## **BAUGH SUBDIVISION**

APPLICATION NUMBER 9 DATE November 5, 2009

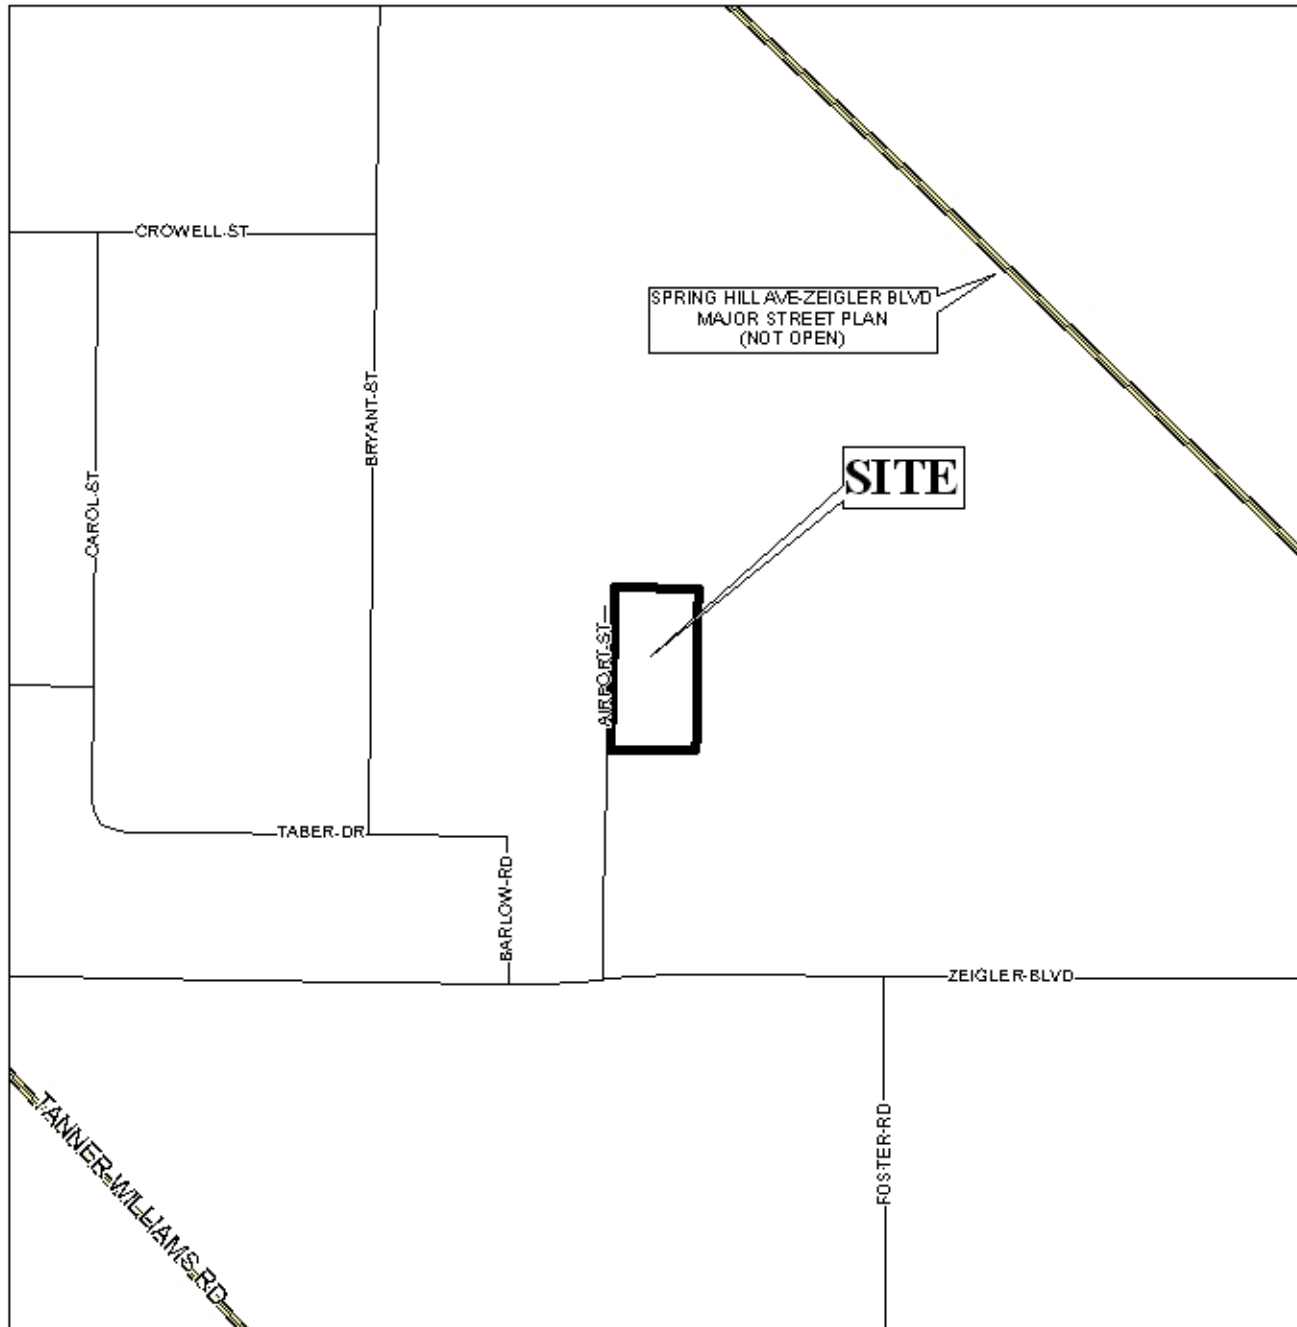
The plat illustrates the proposed 2-lot, 2.7± acres subdivision located on the East side of Airport Street, 5/10 mile± North of Zeigler Boulevard, in the Planning Jurisdiction. The applicant states that the subdivision is served by public water and individual septic systems.

A review of the application indicates that each parcel is under different ownership. However, only one owner signed the application and there is no signature or letter of authorization for the second owner. Also, a review of the plat indicates a discrepancy between the Point of Beginning for the subject property in the furnished legal description and that on the GIS database. As the applicant's surveyor has been notified of both situations and no additional information has been submitted to staff, a complete review and analysis of this application cannot be made. Staff policy is to recommend denial of any application in which all associated property owners have not either signed the application or submitted letters of authorization to be included in the application.

- 1) there is no signature on the application or a letter of authorization from one of the property owners of property involved in this application; and
- 2) there is an unresolved discrepancy between the plat's legal description for the Point of Beginning of the subject property and that indicated on the GIS database.
